Letter of Response

**RE: 35-41 Wilfred Barrett Dr, THE ENTRANCE NORTH NSW 2261
Development Application DA/308/2011**

We refer to the comments from the JRPP meeting dated 17 May 2012. We have since tested a few design options in response to issues raised by the JRPP and we have had a meeting with Wyong Council on 20th June 2012 to discuss the best design outcome. This letter accompanies the revised architectural plans Issue E.

SOLAR ACCESS DIAGRAMS
on 21st June: First Floor Plan

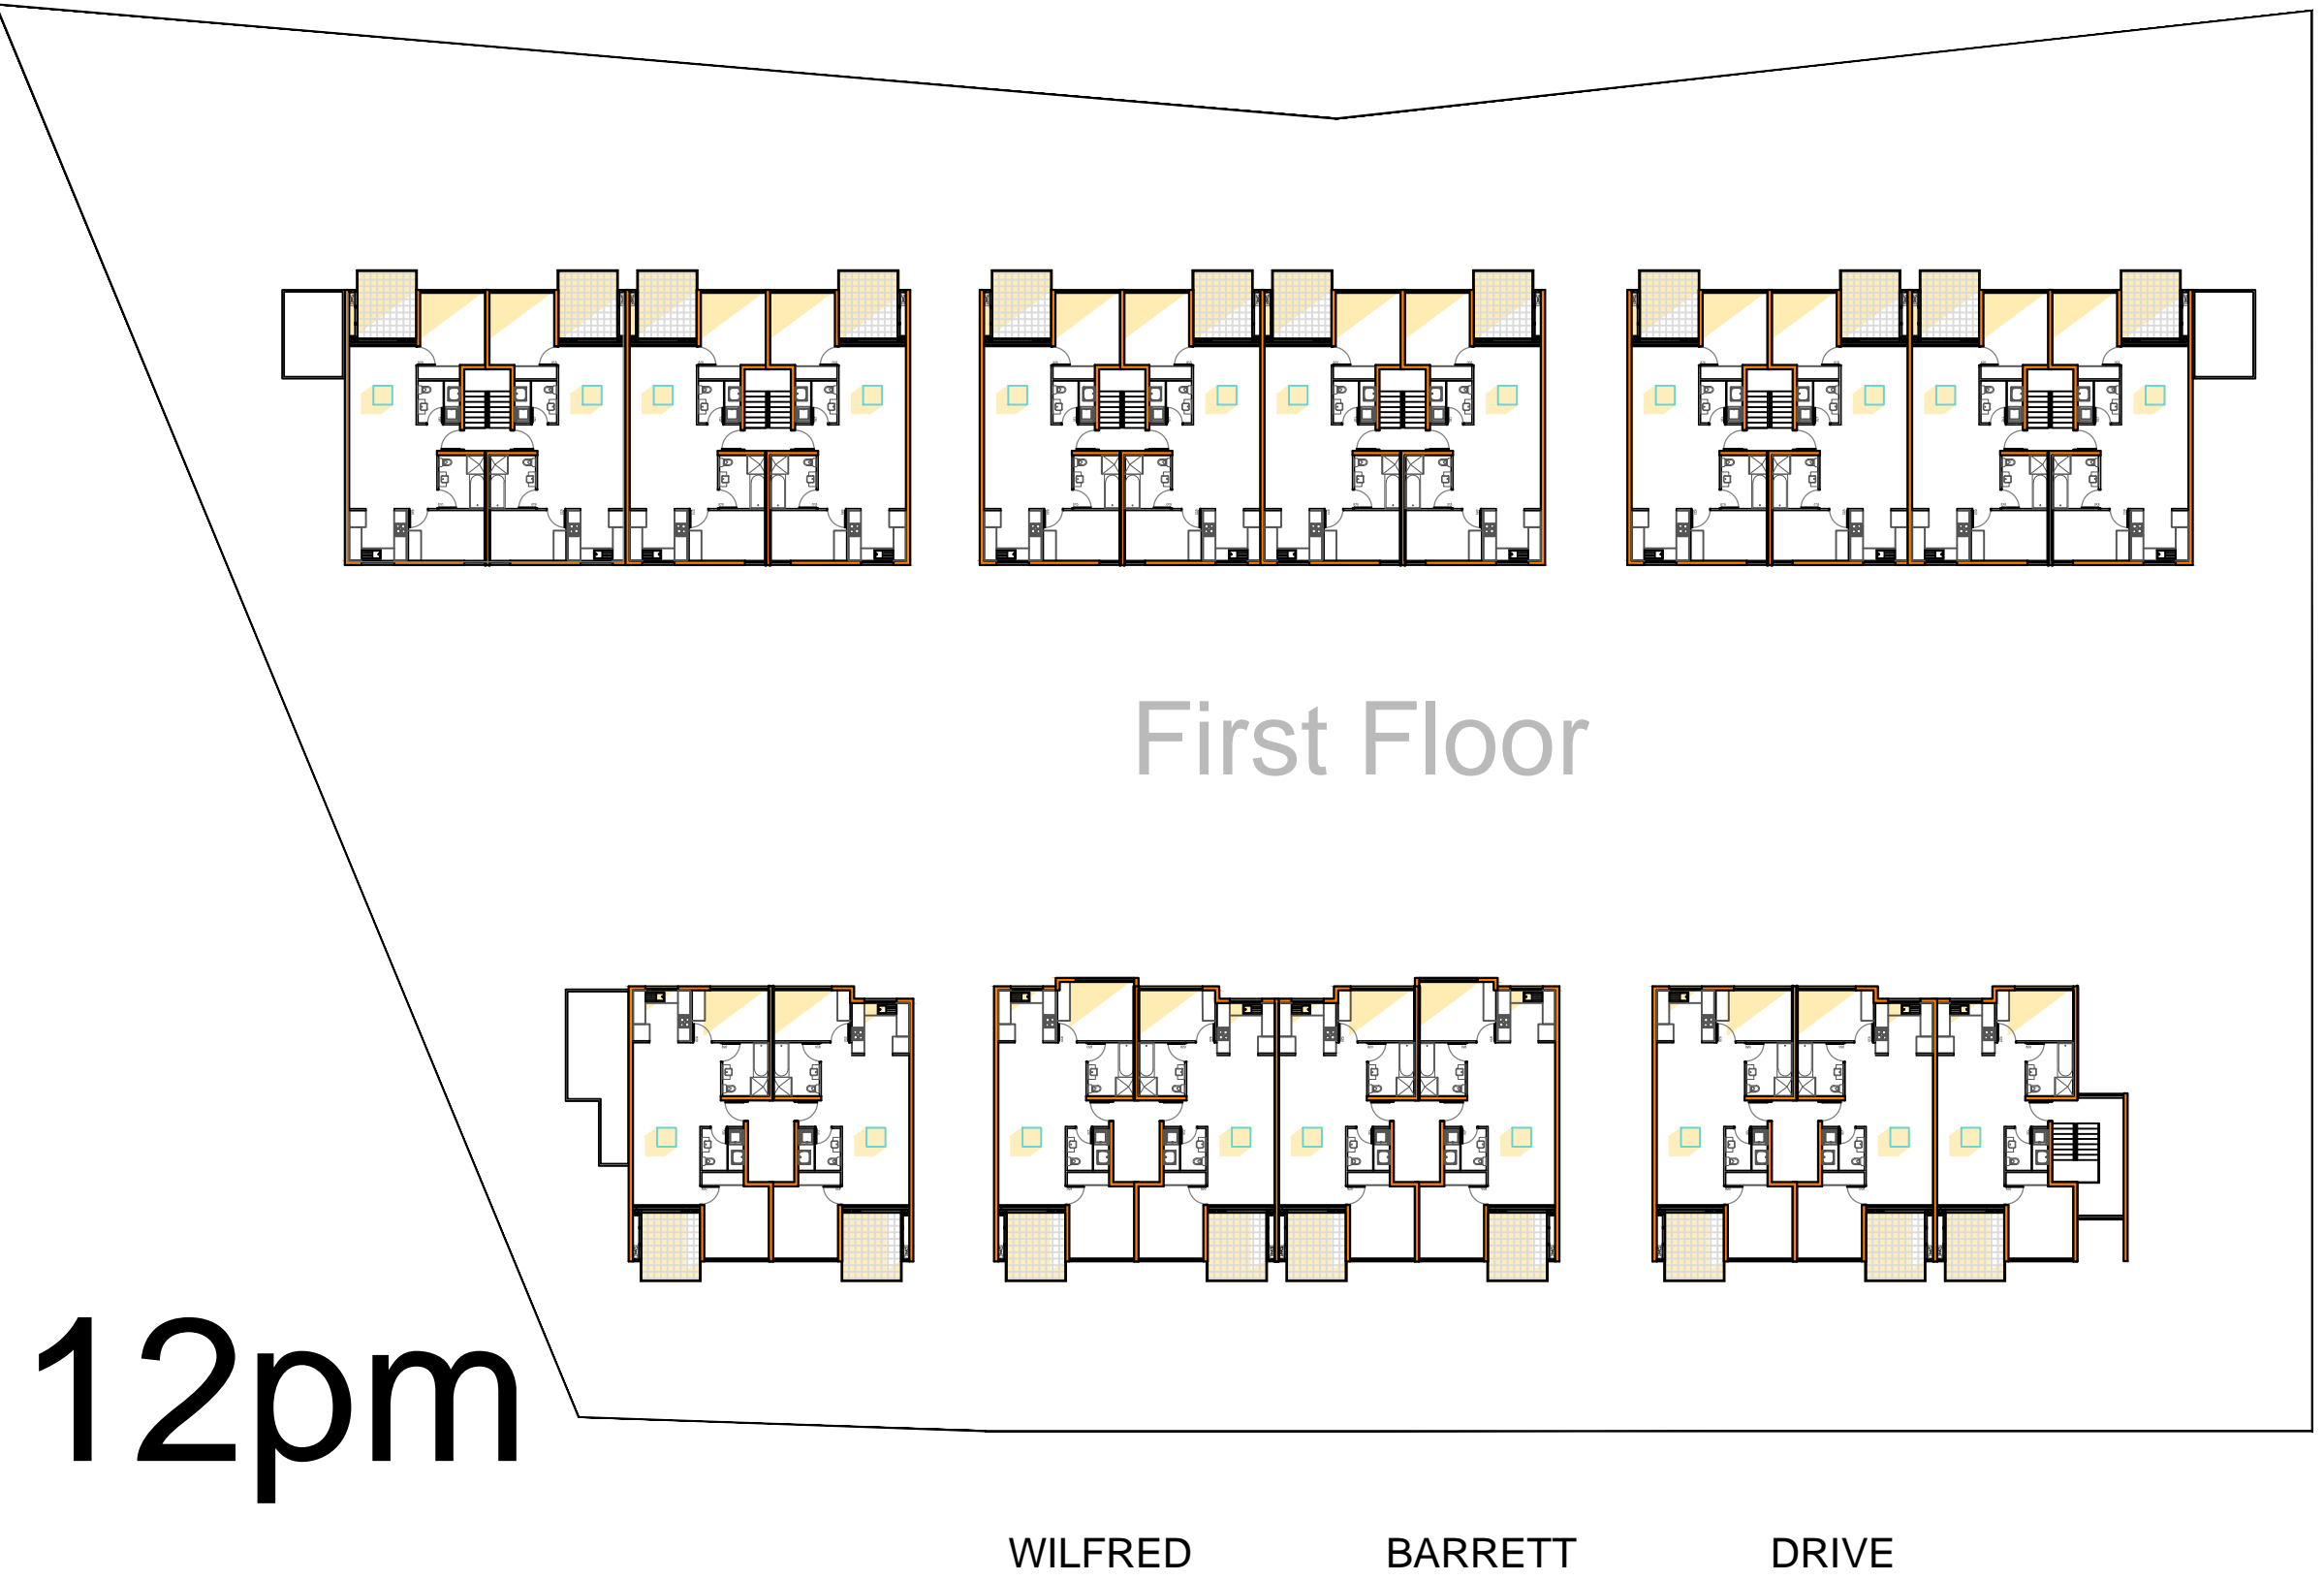
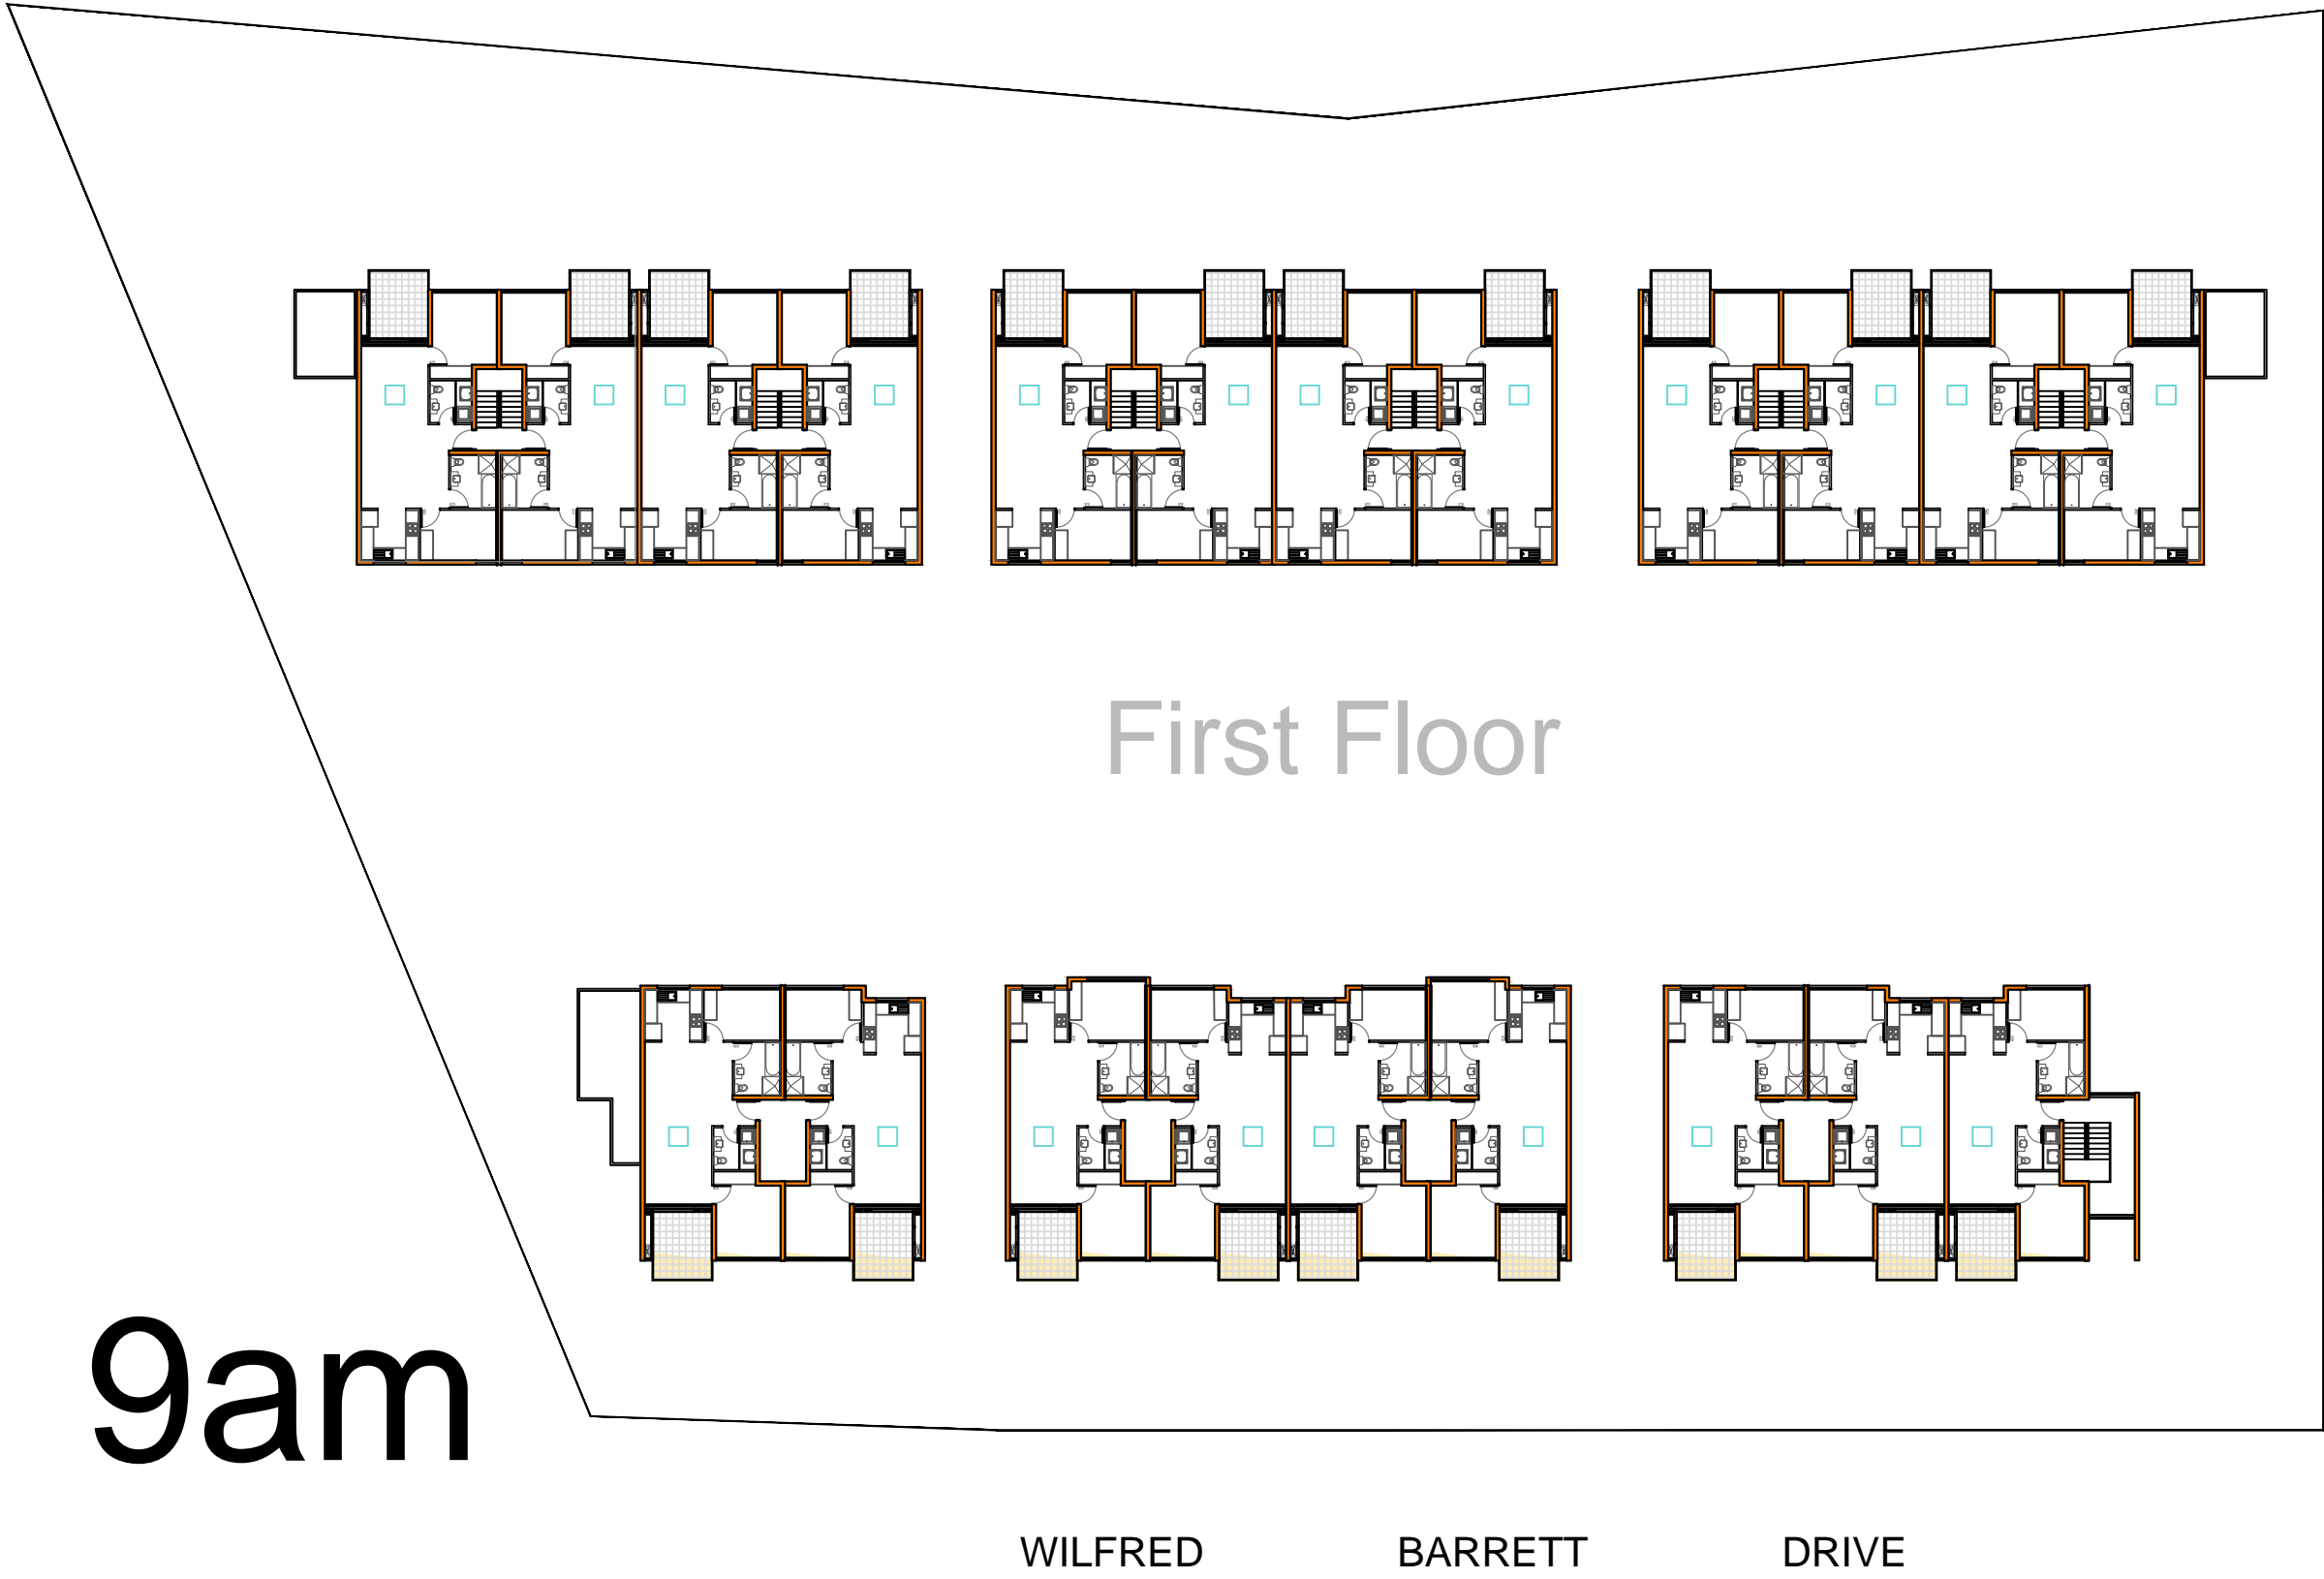
In response to the solar access concern, we have tested 2 alternative design options to increase solar access into units.

Option 2- addition of skylights for all level 1 units. This design option achieves a 79% 3hr solar access into living spaces and private open spaces (exceeding the minimum requirement of 70%). It maintains the initial design proposal of having living spaces and private open spaces of street-front units overlooking the street. By having the living spaces and private open spaces fronting the street will also increase the value of the unit because it is in the aspect of the ocean views. This option not only provides a better amenity, it also enhances passive surveillance to the street (*refer appendix 3 for table of solar access analysis*).

In comparison of the above options, we have concluded that option 2 will be a much better design outcome for the development.
